Modifications to DTC Standards Embassy Suites / 1 Hotel

19 – O'Connell

Joseph F. Pitchford, applicant; 7th Avenue Nashville Hotel Owner LLC, owner.

Reapprove modifications to floor-to-floor heights and projecting sign standards; disapprove modification to the step-back.

New South Elevation (Demonbreun frontage)

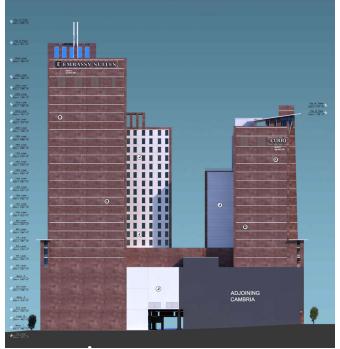
The tower's massing has changed including a reduction of the step-back by approximately 2'. In addition, the lower portion of the tower and several terraces will have greenery installed. The greenery is evergreen and will be "grown-out" prior to installation in order to have the green appearance be immediate, not reliant on several years of growth to mature.

Staff views the changes and addition of the greenery as positive and in keeping with the intent of the DTC, as the design creates visual interest and features a strong human-scale streetscape.

New North Elevation (Cambria façade shown)

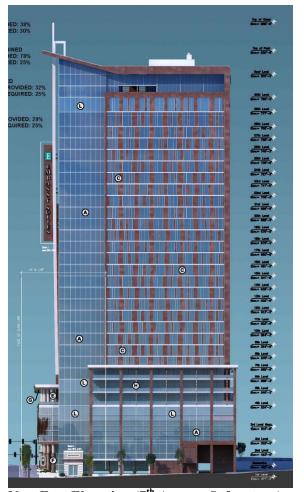
The previously approved plans included E.I.F.S. as a building material on the northern façade, with the majority concealed behind the adjacent Cambria hotel. The material was located in less visible areas, kept away from facades of prominence and monumentality.

The new plans dramatically expand the use of E.I.F.S., particularly in areas of prominence, such as the eastern tower and portions of the western tower that are not effectively screened by the Cambria Hotel. Previously, the material of that façade was proposed to be a metal panel system, which is featured on other sides of the façade. While Planning staff is certainly aware of the welldocumented water infiltration issues of defective E.I.F.S. installation, even facades that are properly treated with E.I.F.S. material can be easily damaged and often appear dated within mere years of installation. The modification to the step-back for both 7th Avenue South and 8th Avenue South increases the amount of visible E.I.F.S. on the building.

The expansion of E.I.F.S. on the western tower would occur on portions of the building that face the Cambria Hotel, which is set back significantly from 8th Avenue South. As the Cambria steps back, the E.I.F.S. material, colored "Incredible White" will be quite perceptible to passersby.

The expansion of E.I.F.S. on the eastern tower occurs on the north façade, which faces an interior lot line, but rises to 30 stories. The applicants are proposing that the lower 65' of the façade remain as metal panel system, but the remainder of the façade be E.I.F.S.

As the modification to the step-back increases the surface area of E.I.F.S. exposed, staff is recommending disapproval of that modification. Staff would support all requested modifications if materials shown on previously approved plans were to be restored. Staff recommends re-approval modifications to the floor-to-floor heights and projecting sign standards, disapproval of modification to the step-back.
